Thank you for the opportunity to review and provide recommendations for the “B” Street Corridor Plan. For the readers’ convenience, Streets for Everyone has summarized our comments below. These are followed by a detailed narrative describing our concerns about the draft and recommendations to fulfill the city’s current TSP goal #1 to “create a ‘green’ template for other cities in the state and nation to follow.”

TO: Ashland Transportation Advisory Committee
From: Gary Shaff
Date: 7/18/2024
RE: B Street Corridor Study

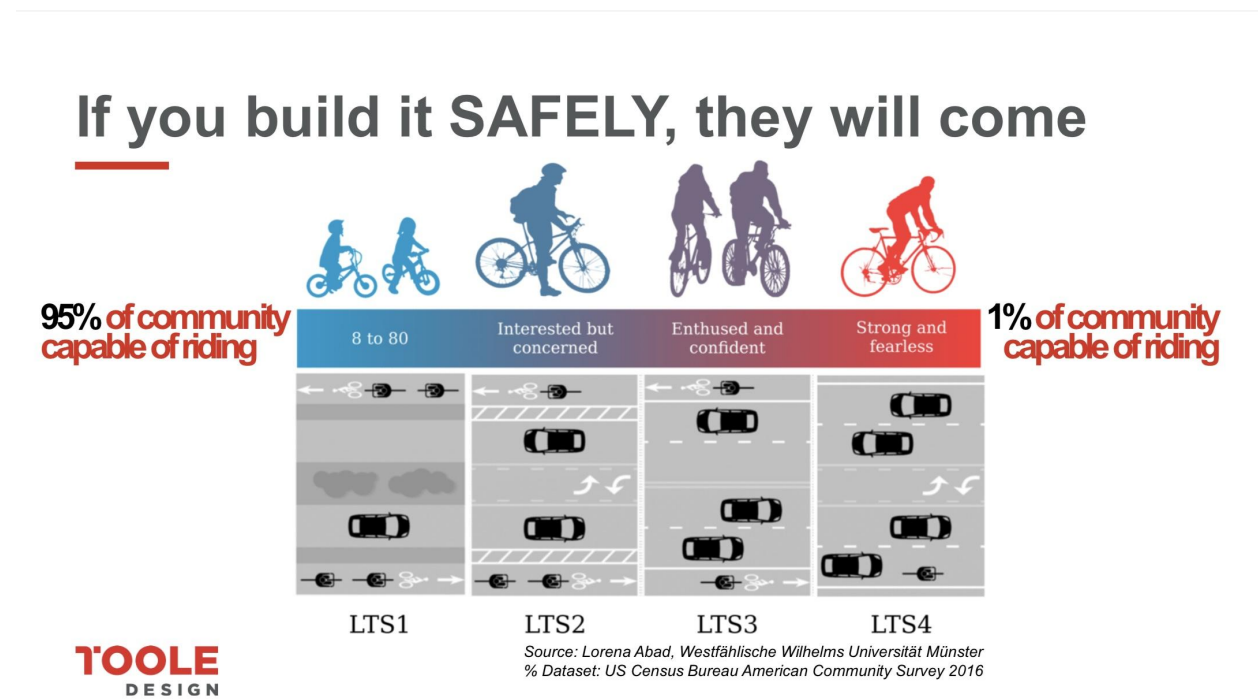
The NACTO document Designing for all Ages and Abilities includes contextual guidance which aids in determining when a bicycle boulevard is appropriate. As the following graphic shows, it should be designated where 90th percentile speeds are 25 MPH or less and traffic volumes are equal to or less than 2,250 vehicles per day. At 3,000 vehicles per day (the consultant's upper threshold for a bicycle boulevard), NACTO's Designing for all Ages and Abilities suggests either a conventional bike lane or, possibly, a buffered bike lane.

The weekday traffic count between 2nd and 3rd street, according to the draft plan (page 6) is 2,479. That is 10 percent higher than is suitable for an all ages and abilities bicycle boulevard bikeway. The consultant's use of "alternative" thresholds meant that little effort was expended analyzing variations in

speeds and volumes within the B Street corridor. Had they used the Designing for All Ages and Abilities thresholds, they would have focused more effort on the section of “B” between 2nd and 3rd, where volumes exceed 2,250 and 90th percentile speeds exceed 25 MPH. Had the consultant used this reference, it is likely that the consultant would have recommended a different set of priorities and changed the timeframes for improvements.

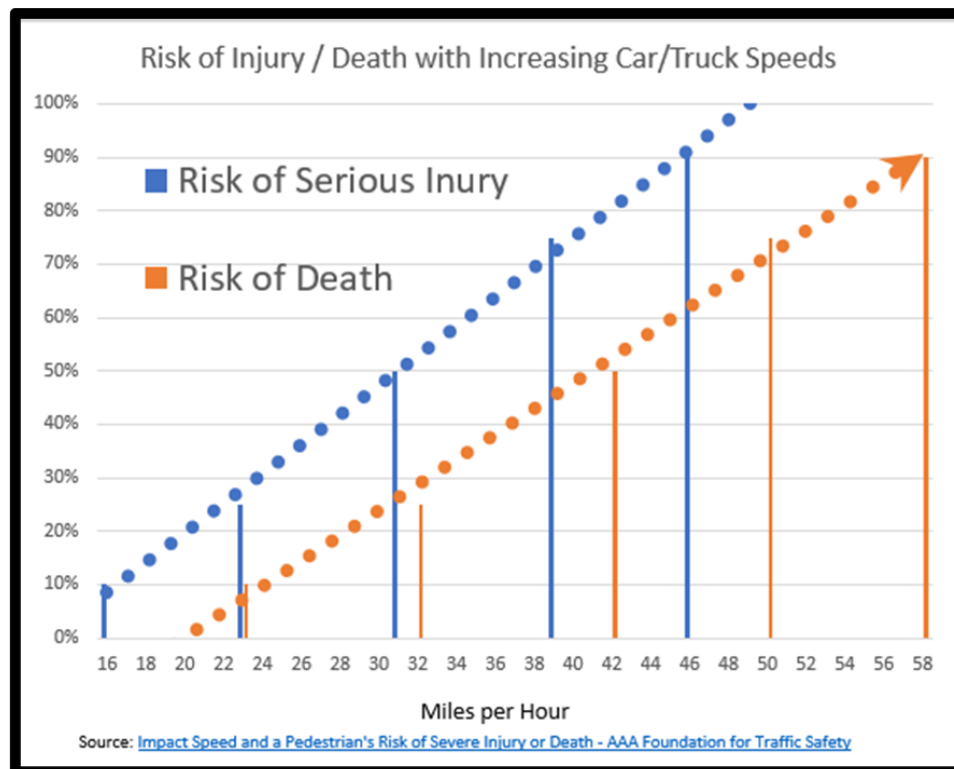
The consultant's recommendation suggests that **sidewalk in-fill** should be a medium or long-term priority. Sidewalk in-fill should be done immediately. Approximately 30 percent of the city's population doesn't drive because:

The consultant's recommendation would ignore or postpone addressing these needs for at least three years or possibly more than eight. Sidewalk infill should be a top priority and completed before any other improvement in the corridor is undertaken.

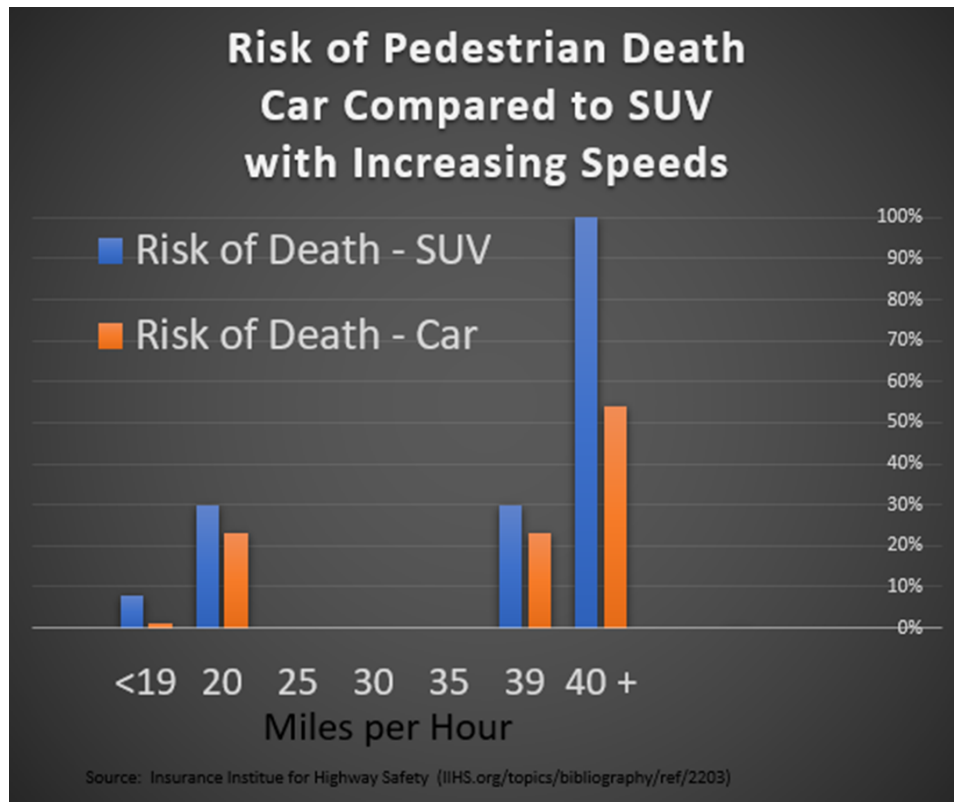
Lowering actual **vehicle speeds** (not posted speed) is essential to protect people walking and bicycling. The graphic below illustrates the marked increase in risk of death at speeds greater than 25 MPH. At 20 MPH, however, the risk of a pedestrian death when struck by an automobile is virtually zero. Notably, that is not the case with larger SUV's and pickup trucks which, by the design of the vehicle itself, increases the risk of death for pedestrians when struck by a vehicle traveling at 20 MPH or higher significantly more than smaller vehicles.

Ashlander’s vehicles, in contrast with other metropolitan communities, own a higher proportion of large SUV’s and pickup trucks. The speed limit on B Street, as the consultant suggests, should be reduced to 20 MPH (slower would be better). More importantly, traffic-calming features must be added to ensure that actual vehicle speeds are 20 MPH or less and driver behavior naturally gives priority consideration to bicycles and pedestrians.

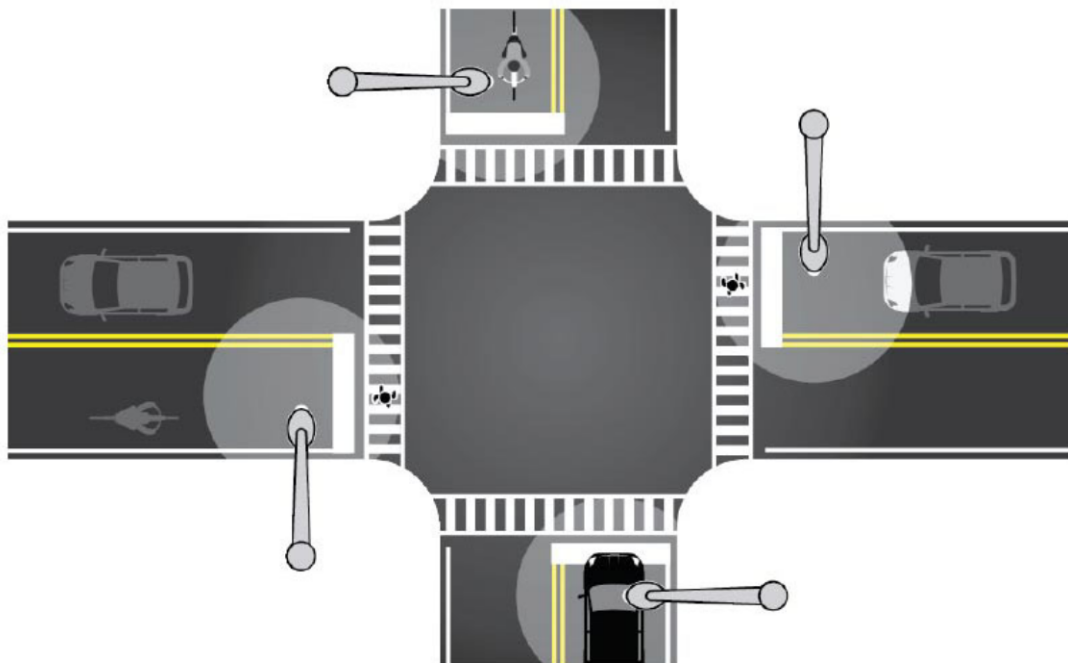
The draft report did not include an inventory of **street lighting**. We observed that a single light pole is present at most, but not all, intersections along the "B" street corridor. The only pedestrian scale lighting

on “B” is between Oak and Pioneer by the Armory. We recommend that pedestrian scale lighting extend from Water

Intersection illumination (via street lights) should be improved at all intersections and, at a minimum, conform to AASHTO’s recommendation.

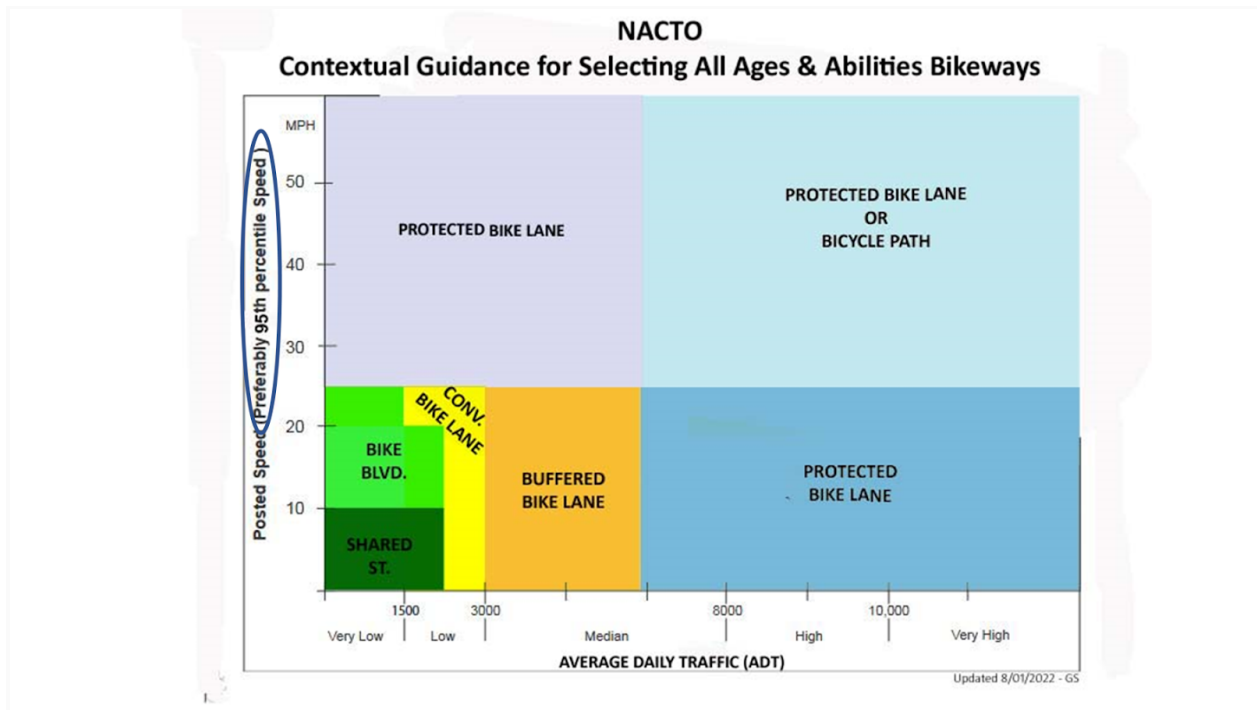
The Rule provides for the use of the National Association of City Transportation Officials (NACTO) document entitled “[Designing for All Ages and Abilities](#)” (OAR 660-12-610(5)b). Below is a graphical simplification that uses vehicle speeds (y axis) and traffic volumes (x axis) to determine the appropriate “all ages and abilities” bicycle facility designs for city streets.

It is critical that 90 percentile speeds, as recommended by NACTO, be used in establishing bicycle facility designs in the city. That way children, as well as adults with beginner bicycling skills can safely utilize the resulting network.

- 1) traffic volumes throughout the corridor remain under 2,250 ADT, and
- 2) 90th percentile speeds fall below 25 MPH

and thus appropriate for a bicycle boulevard (per NACTO guidance - see graphic above),
